TRANS/WP.29/GRE/2003/33  
7 July 2003

PROPOSAL FOR A DRAFT AMENDMENTS TO REGULATION No. 113

(Headlamps emitting a symmetrical passing beam)

Transmitted by the expert from the Working Party "Brussels 1952" (GTB)

"Annex 8

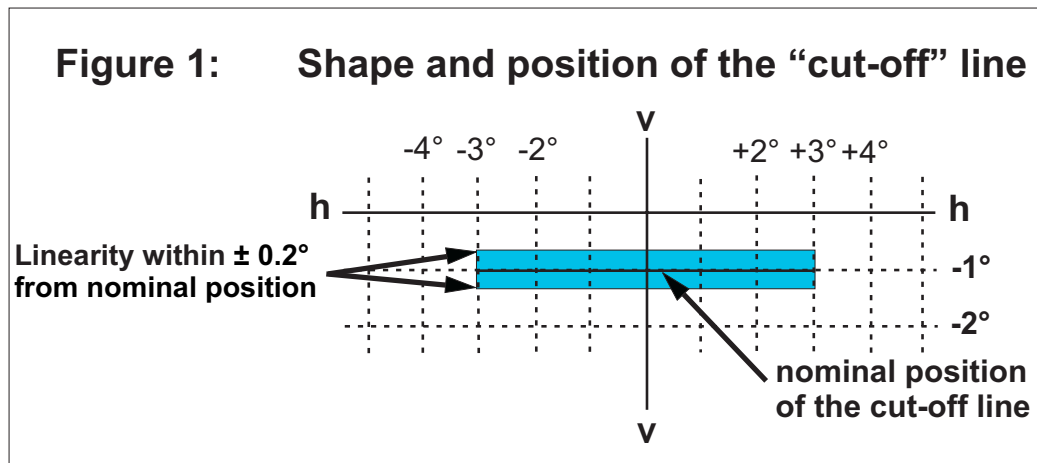
2.1. For visual adjustment of the symmetrical passing-beam headlamp the cut-off line shall provide: a horizontal line for vertical adjustment of the symmetrical passing-beam headlamp extending to either side of the v-v-line (see Figure1) as specified in paragraph 6.2.1. of this Regulation.

If the horizontal part is not straight but slightly curved or inclined, the cut-off line shall not exceed the vertical range formed by two horizontal lines which are situated from 3° left to 3° right of the v-v-line at 0.2° for class B and [0.3°] for class A, C and D head lamps above and below the nominal position of the cut-off (see Figure 1).
